CITY OF ROCKVILLE PLANNING DIVISION STAFF REPORT

October 10, 2000

Detailed Application CPD2000-0004F for
Comprehensive Planned Development
CPD1999-0004, Fallsgrove

Grocery Store & Retail – from Falls Grove Blvd facade

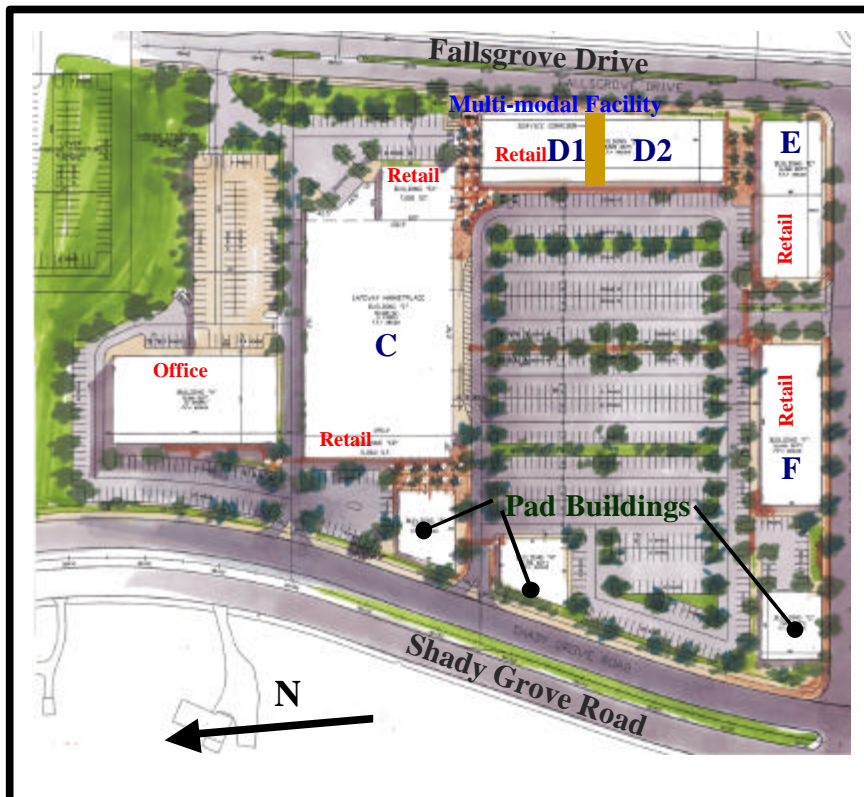
The largest of the retail buildings at 69,380 square feet, this building will house the 56,520 square foot grocery store, which faces internal to the site, and will be the primary architectural focus of the Village Center. In keeping with the Applicant’s representation during the review of the Concept Plan that this center be of a “four-sided architecture” approach, there will be a 5,860 square foot general retail portion of this building that will turn the corner of the main building and face Shady Grove

Road. The façade will continue along a pedestrian plaza/courtyard across an access road, connecting to the office building beyond, creating the feel of interconnectedness. The large pedestrian plaza/courtyard on this corner will also run between the retail façade and one of the pad sites.

Shady Grove Road Elevation

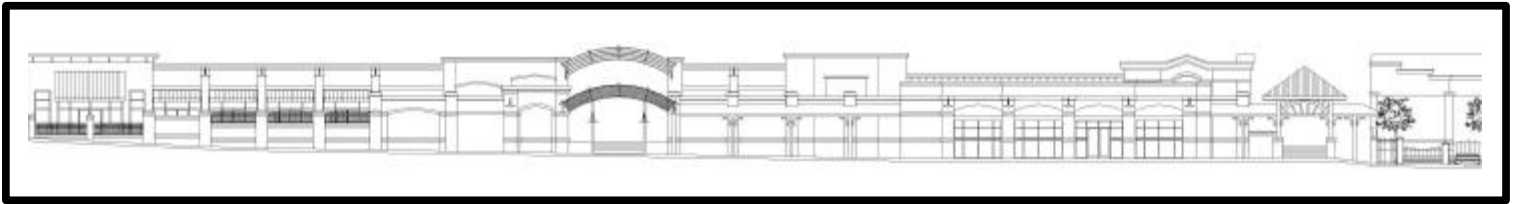
The Applicant and City Staff have been working to create a site that has a mix of uses and elements that function interdependently. An example of this interdependence is the retail facing Shady Grove Road that links the grocery store to the office building. Another is the parking structure associated with the building. At 190 spaces, the deck will serve the office building's parking requirements as well as some of the retail component. The deck will be of similar architecture as the rest of the site, and will contain the same design elements as the entire Fallsgrove development.
